Quotation Number 1 - Grades between William Burgess and the Judicial Complex

Quotation Number 2 - Subgrade problems in parking areas

APPROVED *Quotation #1 only*

PROPOSED
POND
EXTENSION

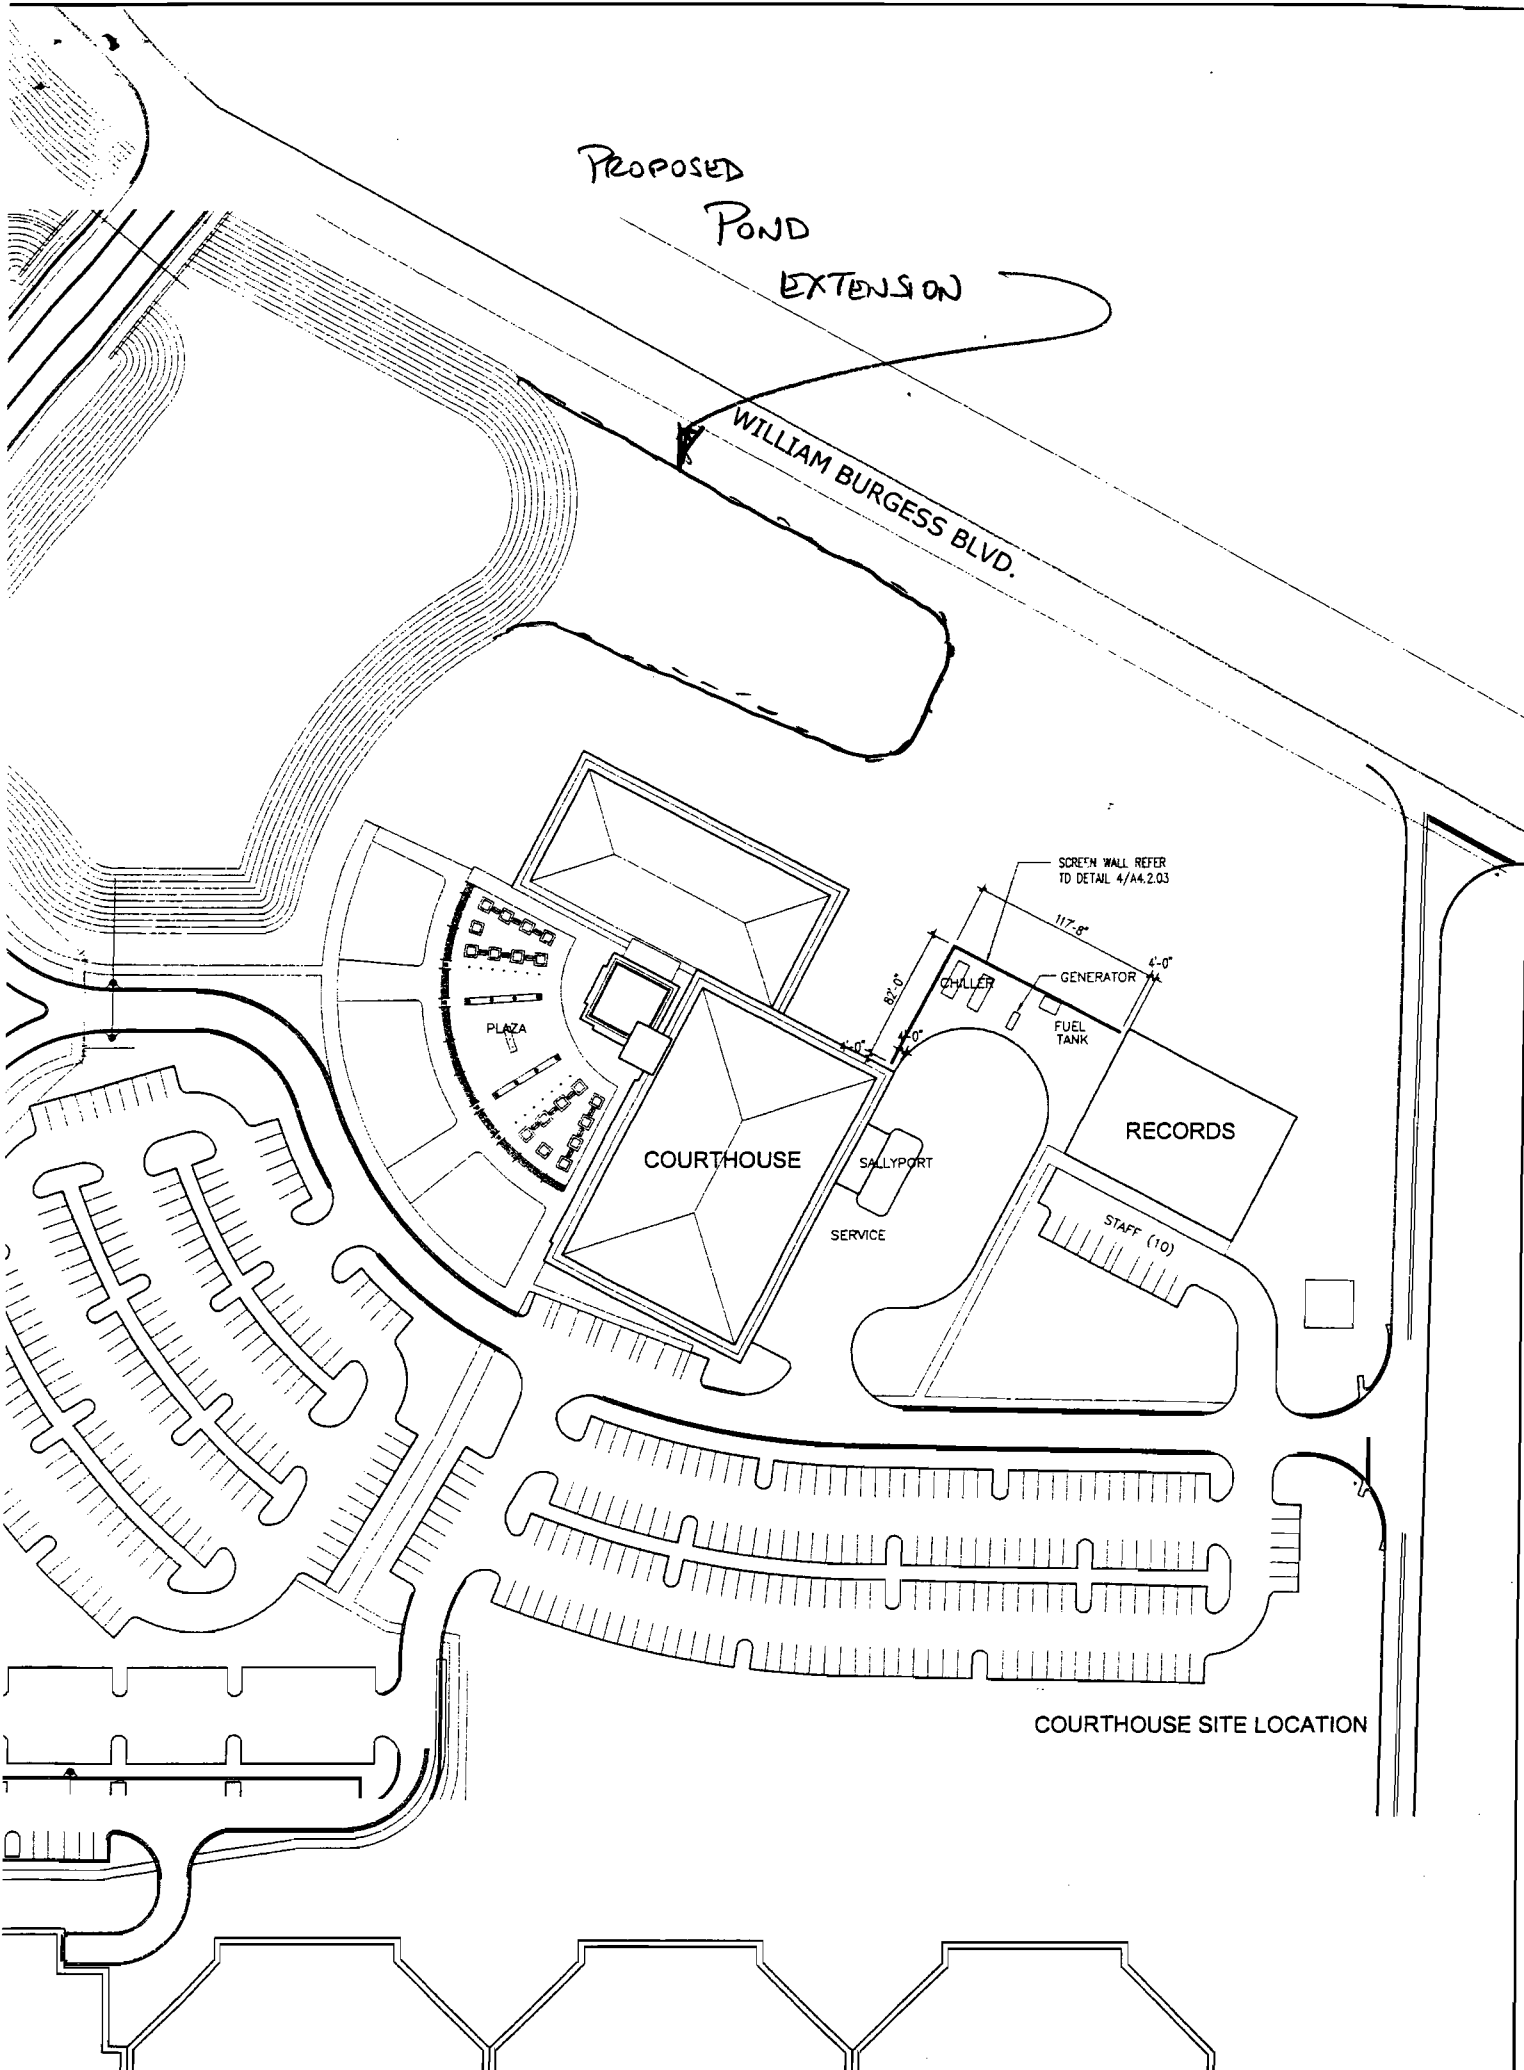
We have been asked to price additional work for the pond extension/grading between the road and buildings. In accordance with the attached drawing, the pond will be extended along William Burgess approximately 90 LF wide by approximately 200 LF by 6 feet deep. The excavated fill will be used to bring the rest of the site up to an appropriate grade.

D6 Dozer: 3 weeks; 120 Hrs @ \$ 80.00/Hr = \$ 9,600.00

Track hoe & Truck for 2 weeks: 80 Hrs @ \$165.00/Hr = \$13,200.00

Total = **\$22,800.00 [Not to EXCEED]**

This is in lieu of importing approx.. 1,100 loads of Fill plus spreading to grade - \$90,000.00
